BID REQUEST ADDENDUM NUMBER TWO (2)

JULY 16, 2020

RFP NO. 2020-05- LIFT STATION 42 REHAB & UPGRADE-REBID

CITY OF EDINBURG

MONOLITHIC FIBERGLASS MANHOLE DETAILS

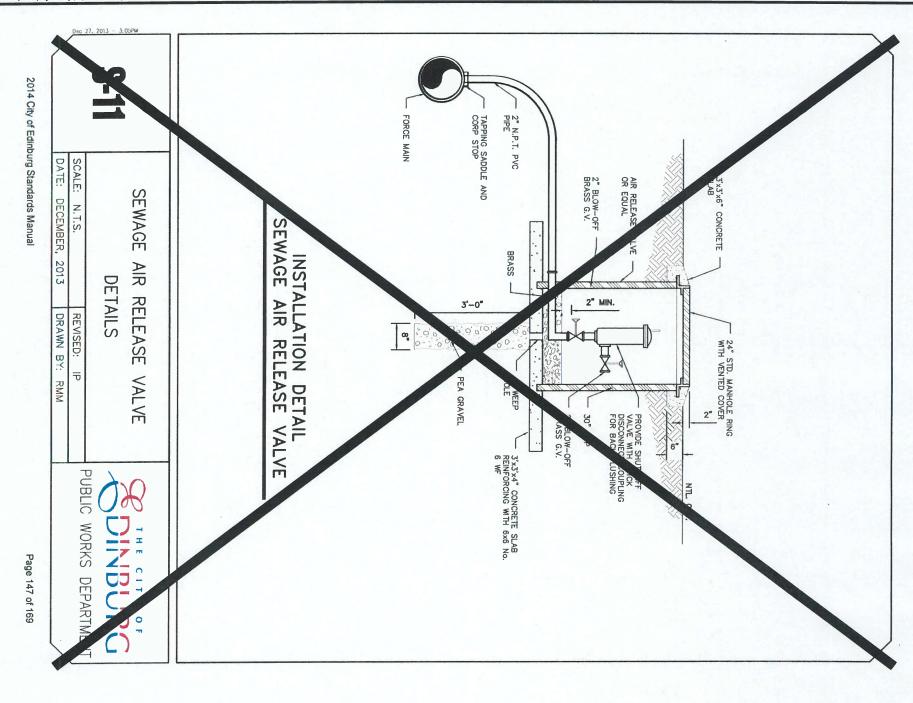
- REVISED DRAWING T1 ADDED TWO ADDITIONAL DRAWINGS
- REVISED DRAWING C21 DISREGARD S-3 FIBERGLASS MANHOLE DETAILS
- INCLUDE ADDITIONAL DRAWING C21A
- REVISED DRAWING C23 DISREGARD S-11 SEWAGE AIR RELEASE VALVE DETAILS
- INCLUDE ADDITIONAL DRAWING C23A
- DUE DATE AND TIME REMAIN UNCHANGED. PLEASE USE FOLLOWING:

ADDED ADDITIONAL DETAILS (C21A & C23A) (ADDENDUM #2) 7/15/2020 HPG DESCRIPTION DATE REVISION BY

AIR RELEASE VALVE AND MANHOLE FORCEMAIN DISCHARGE MANHOLE DETAIL

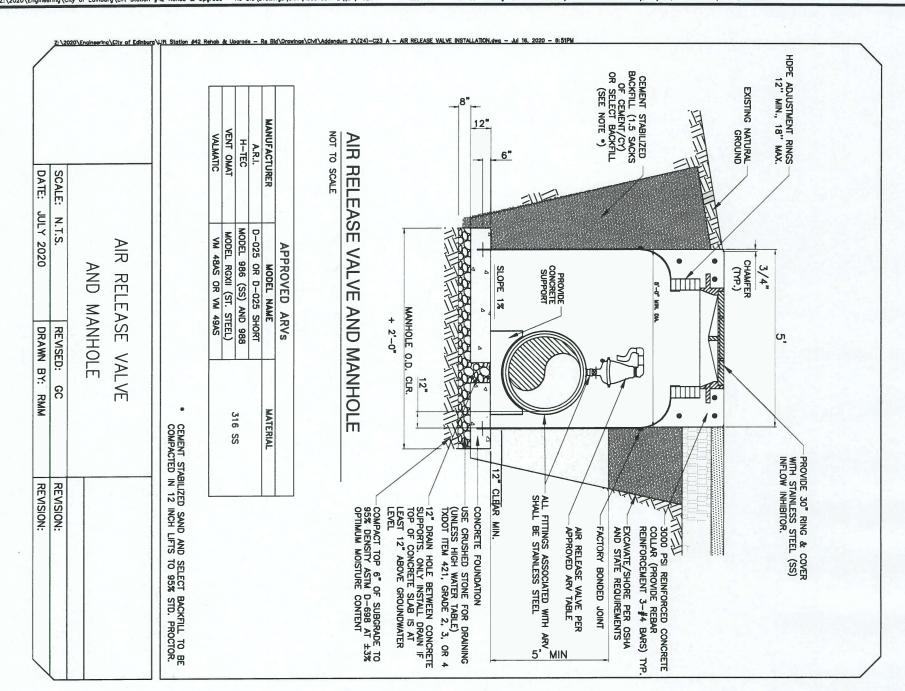
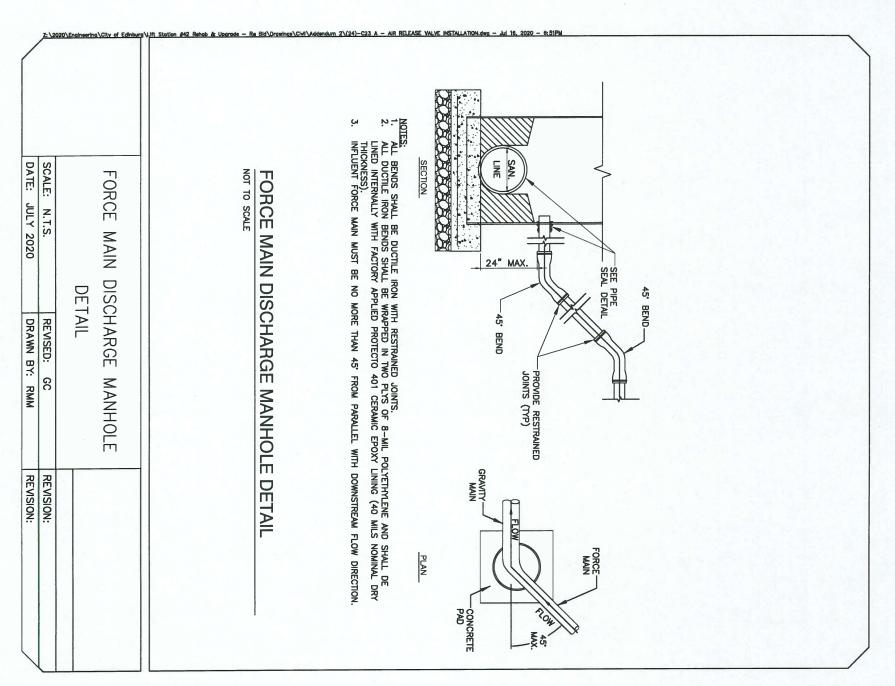
1	7/15/2020	HPG	DISREGARD DETAIL S-11 (ADDENDUM #2)								
REVISION NO.	DATE	BY	DESCRIPTION		REVISION NO.	DATE	BY		DESCRIPTIO	N	
SHEET 24	DRAWING N	LIFT	CITY OF EDINBURG STATION 42 REHAB & UPGRADE-RE BID	Ed	inbura			PROJECT NO.			CONSULTANT'S PROJECT NO.
of 36	3	-	AIR RELEASE VALVE INSTALLATION CONCRETE THRUST BLOCKS	PRINTE SUL 200-0004 PAIN 900-000-7413		4	S W. LIGHTHOUTY DANKE EDGELINA, TX 70041	PHONE SOLESALESAL PAIR SOLESALESAL	ONSULTING ENGINEERS 1721 H. GLONER BURD, GUILL B BROWNE, TX 76541	95680 //CENS ^C 9	SHEET 20580-04

ADDED ADDITIONAL DETAILS (C21A & C23A) (ADDENDUM #2) 7/15/2020 HPG DESCRIPTION BY REVISION NO. DATE
